ENGINEERING RESPONSE TO NRC COMMENTS ON THEDURANGO DRAP Distribution:

Calculation Cover Sheetrec'd w/ eng. response to NRC
Comments on the Durango Ditch
Dur-10-85-05-02-02Contract No. UMTRADiscipline CIVILCalc. No. _____
No. of Sheets 11

EROSION PROTECTION - Finalized embankment
perimeter ditches

Cross Section ①

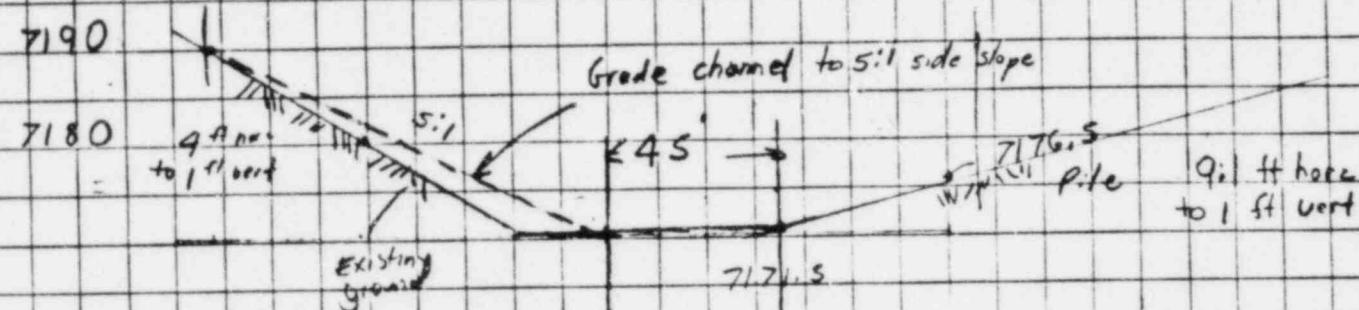
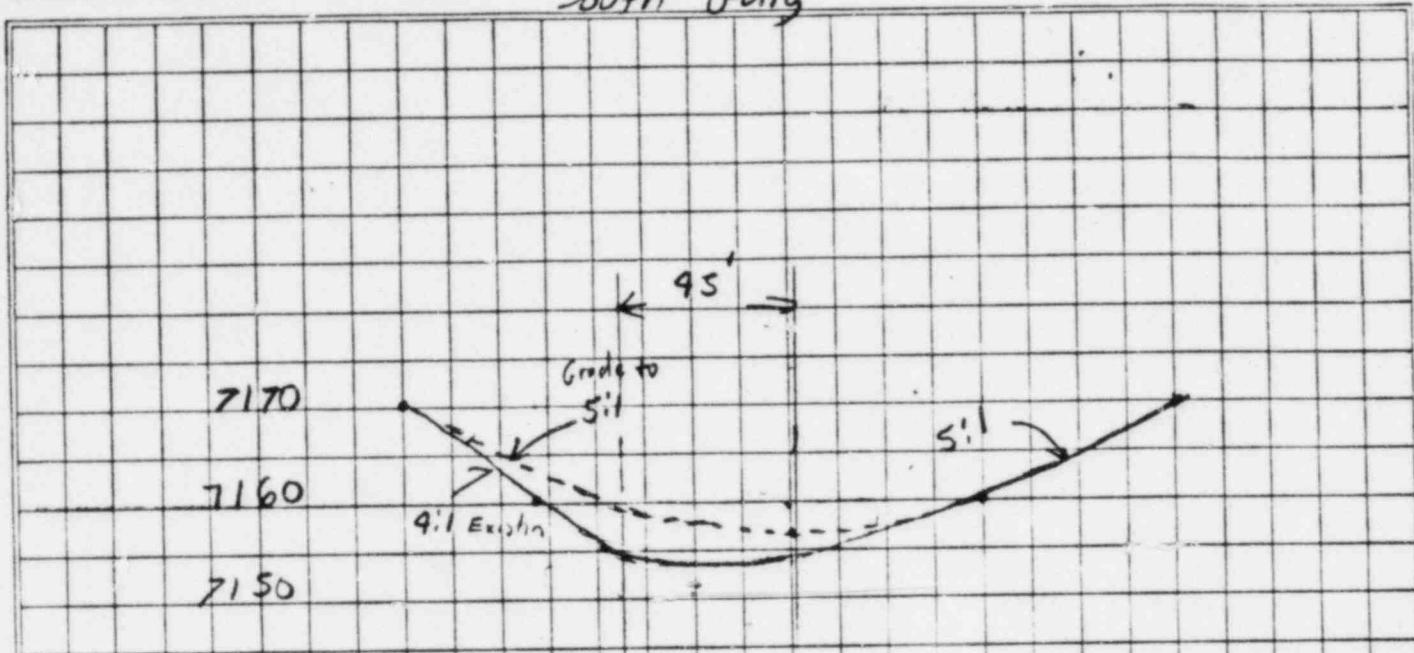
Cross sections 1, 2, 3 & 4 are shown on pages 2 & 3. Cross section 4 approaches the worst case situation and approaches a cross section of a trapezoidal with 5:1 side slopes; a base of 45 feet and a bed slope of 12.5% (8:1). This cross section was used when sizing the rocks for the south gully erosion blanket.

Cross Section 5

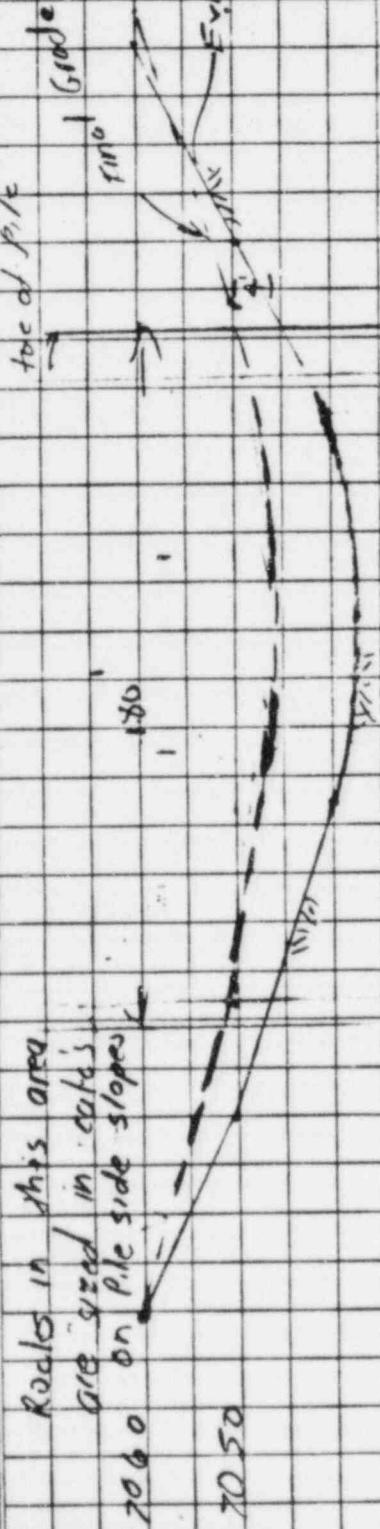
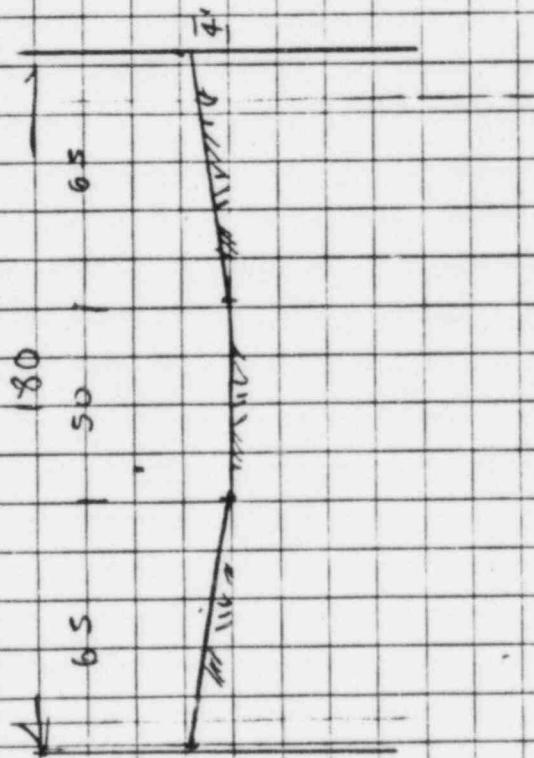
Cross Sections 5 and 6 are shown on pages 12 & 13. The contributing drainage area for cross section No. 5 is 15.1 Ac. (^{Area outlined} in Green) assuming a t_c of 2.5 min the flow for cross section 5 is as follows:

FIGURE 1
LARGE DIAMETER BORROW MATERIAL
DURANGO, COLORADO

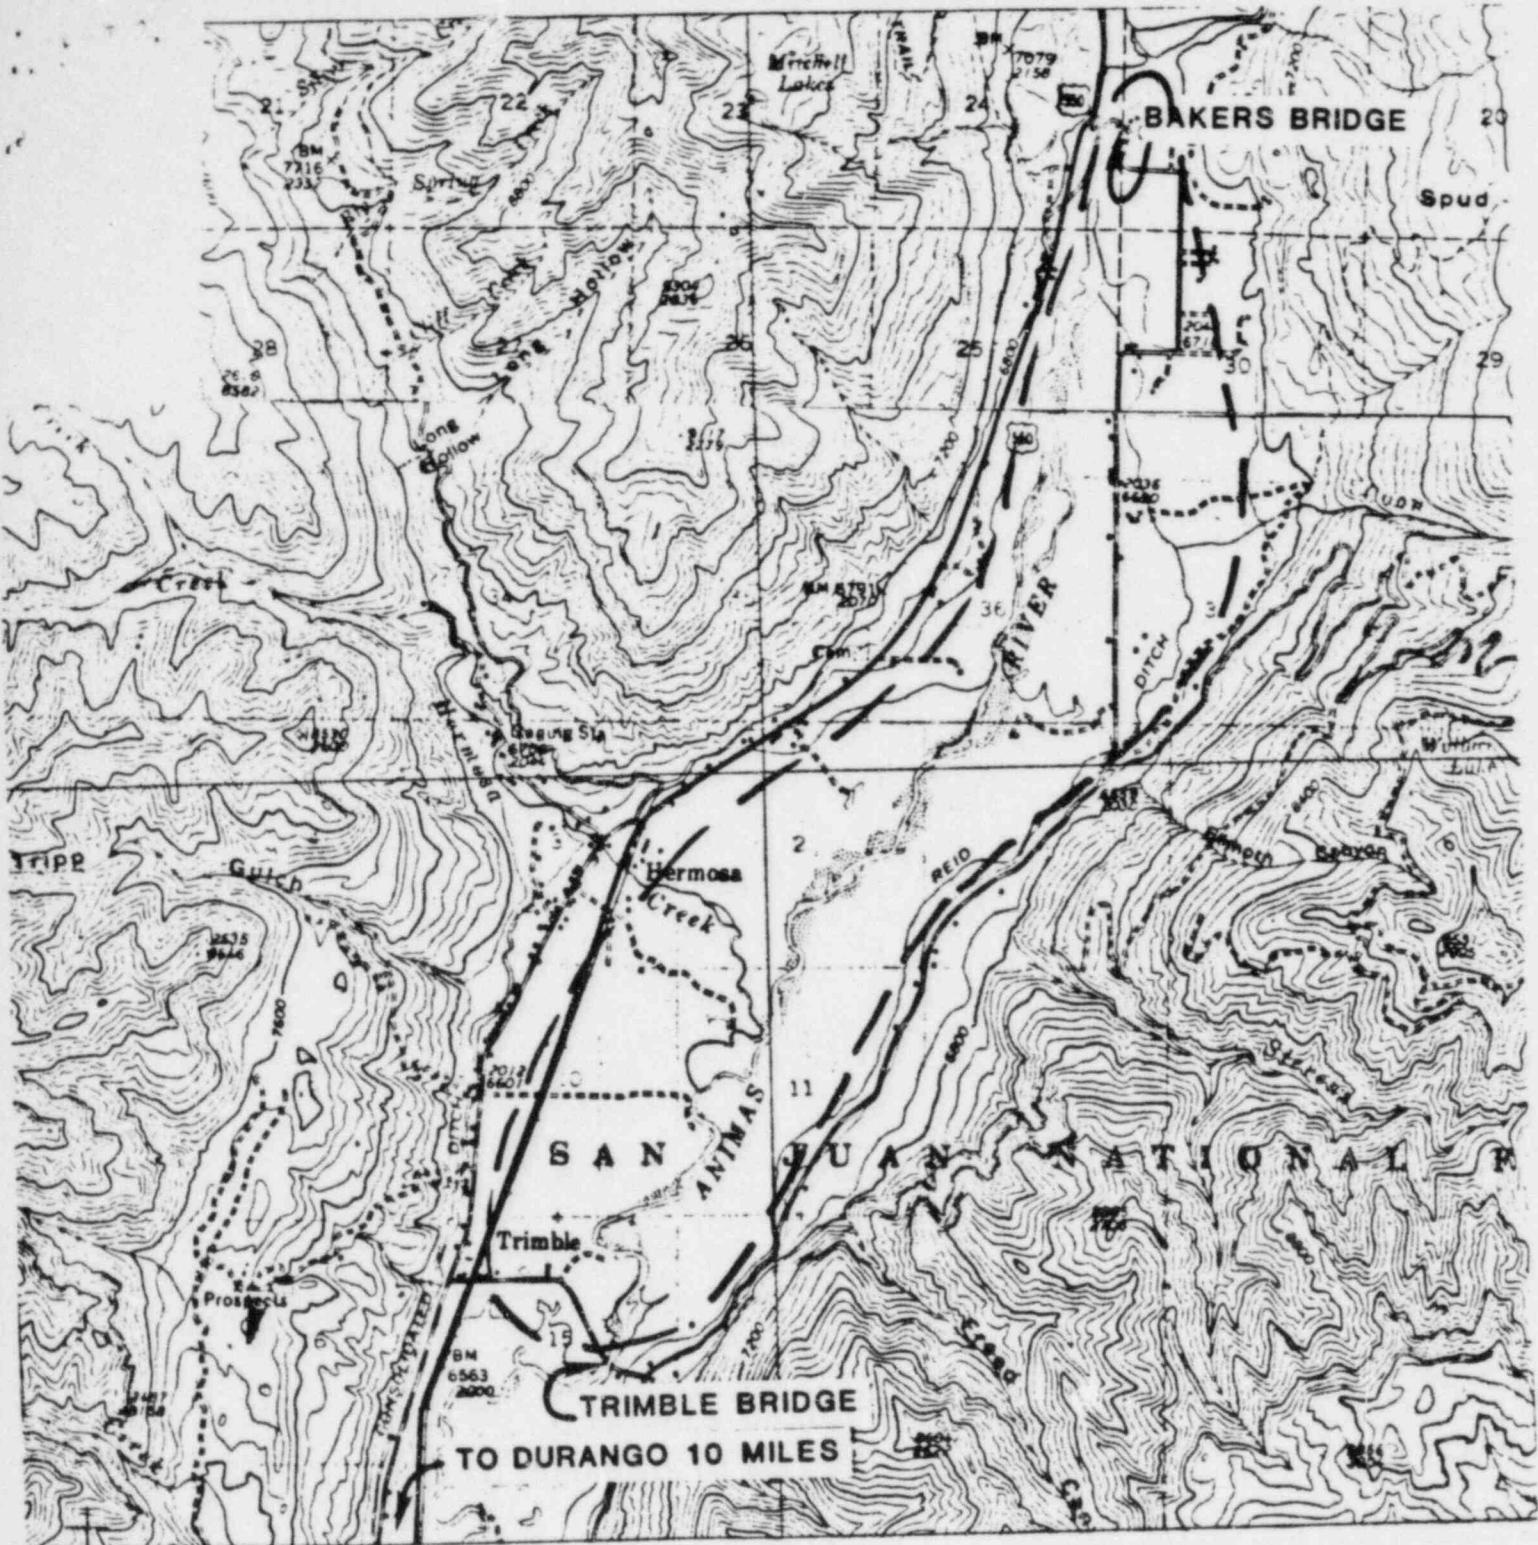
I met with Ron Pettigrew of Burnett Construction, a large general contractor in Durango, to discuss the availability of large diameter, durable rock sources in the Durango area. Ron tells me that Burnett Construction and Animas Aggregate (a local sand and gravel operator) have gravel pits in the Animas River Valley, north of Durango, that yield this type material (8 in. to 20 in. diameter). The locations of these gravel pits are in a 4.5 mile stretch along the Animas River, north of Durango, between the Trimble Bridge and Bakers Bridge (Figure 1).

Apparently, past fluvial conditions have occurred upstream of the present Trimble Bridge that created an area along the ancient Animas River that acted as a distilling basin where large diameter rock dropped out of the flow regime of the river. Thirty feet or more of sandy gravel to bouldery alluvium is present in this 4.5 mile stretch of river. According to Ron, pilings driven for a bridge in this area went down to 70 feet and still did not encounter bedrock.

FIGURE 2
LARGE DIAMETER BORROW MATERIAL
DURANGO, COLORADO

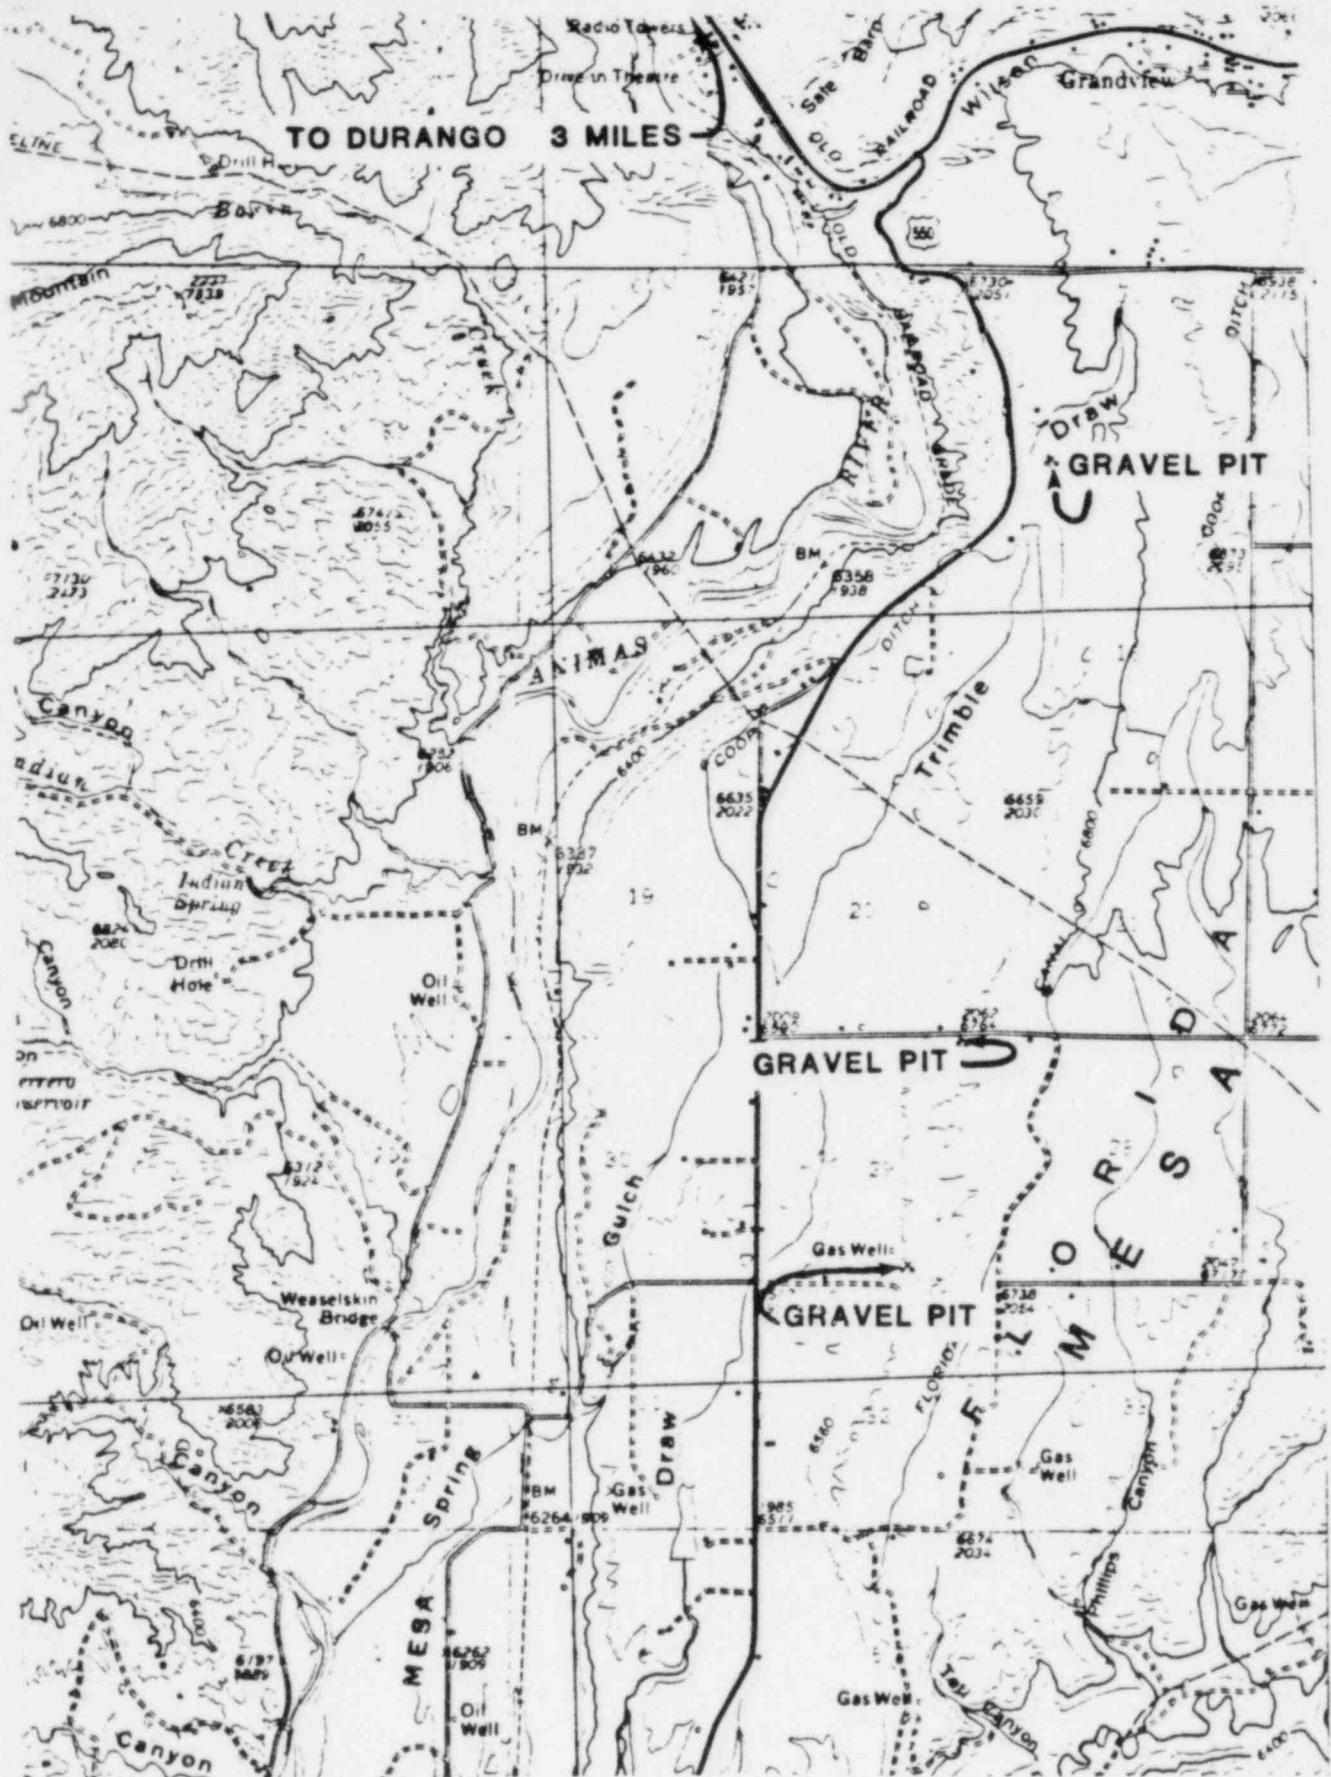
Other potential areas for oversized rock are to be found south of Durango, on Florida Mesa, along the east side of the Animas River (Figure 2). Several gravel pits are located on this mesa which show large, 8+in. diameter, material in the sidewalls of the excavated pits.
